# WGB014 Gear Box

## Assembly suggestions

For 2mm axles

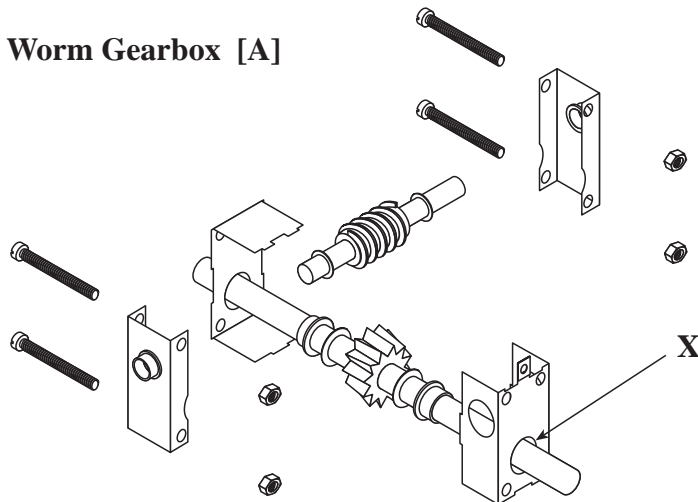
The axle bearings have been change to shorter one more appropriate to a gearbox, however they have a larger outside diameter. To get these new bearings to fit the hole in the sideplates marked 'X' will have to be eased with a broach.
